PLANNING COMMISSION AGENDA

CITY OF NOVI

1. JSP26-08 OPTIMUS SPORTS TRAINING FACILITY

Consideration at the request of ZAF Investments for approval of Special Land Use, Preliminary Site Plan, Stormwater Management Plan, and Woodland Use Permit. The subject site is located at 43700 W. Twelve Mile Road and consists of approximately 4.34 acres (Section 10). The applicant proposes opening an athletic training center.

CITY PROJECT NUMBER: JSP24-0008
 SCALE: 1" = 30' PROJECT ID: DET-030411
 TITLE: DEMOLITION & TREE REMOVAL PLAN
 DRAWING: C-2.0

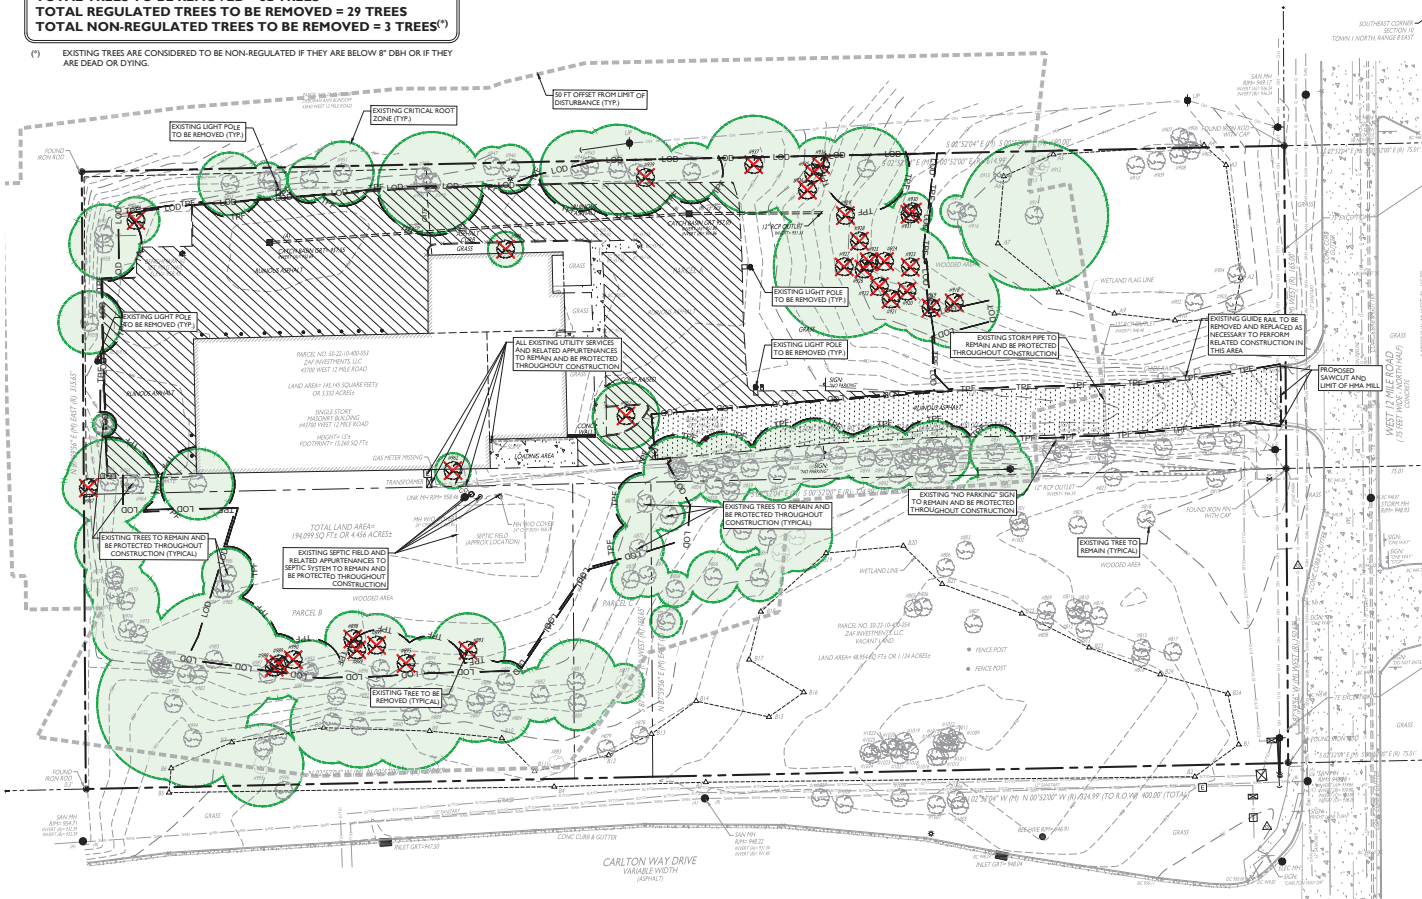
6. **Woodland Replacement.** Based on a review of the plan, the applicant is proposing to remove 29 regulated trees. The number of trees to be cut that have a DBH of eight inches or more have been summarized on Sheet C-2.0 and are summarized below.

The Demolition and Tree Removal Plan has been revised to provide an updated ‘Woodland Replacement’ table that accurately lists the amount of trees to be removed per size category. A total of 31 existing trees are indicated to be removed, 29 of which are regulated per the ordinance. No existing woodlands are to be disturbed within the existing conservation easement. 63 total replacement trees are required. Please see the updated plan sheet C-2.0.

The Demolition & Tree Removal plan provides an updated 'Woodland Replacement' table that accurately lists the amount of trees to be removed per size category. A total of 31 existing trees are called out to be removed, 29 of which are regulated per the ordinance. 63 total replacement trees are required. Please see the updated plan sheet C-2.0.

CITY PROJECT NUMBER: JSP24-0088
 SCALE: 1" = 30' PROJECT ID: DET-25411
 TITLE: LANDSCAPING PLAN
 DRAWING: C-8.1

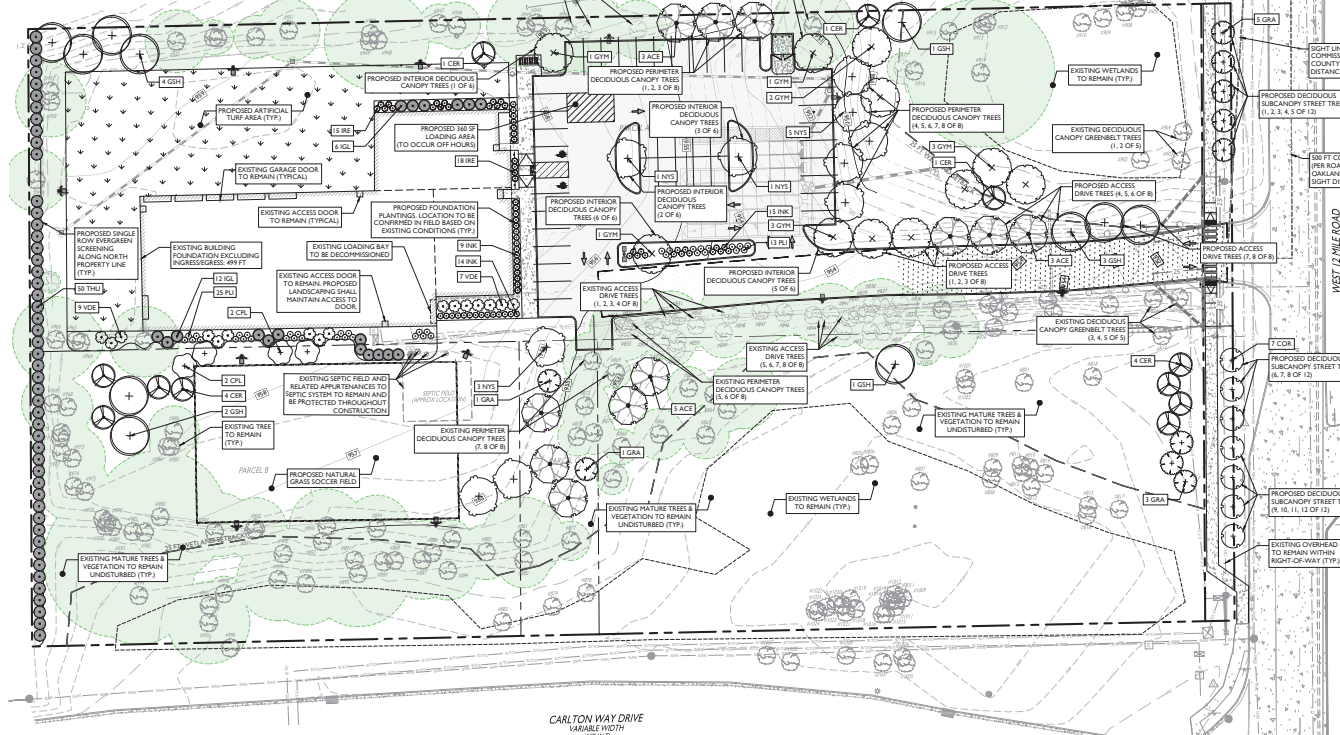
8. Provide a prominent note on sheet C-8.1 that the irrigation system will be connected to a private on-site well.

Acknowledged - This note is included on the Landscaping Plan and will be added to the irrigation plan prior to the final submittal. Please see updated sheets C-8.0 and C-8.1.

The Landscaping Plan has been revised to indicate the proposed loading area which is located immediately south of the existing building to remain. The proposed loading area is located approximately 300 ft away from the West 12 Mile Road right-of-way and will be screened by existing woodlands to remain and additional proposed trees. Please see the updated plan sheet C-8.1.
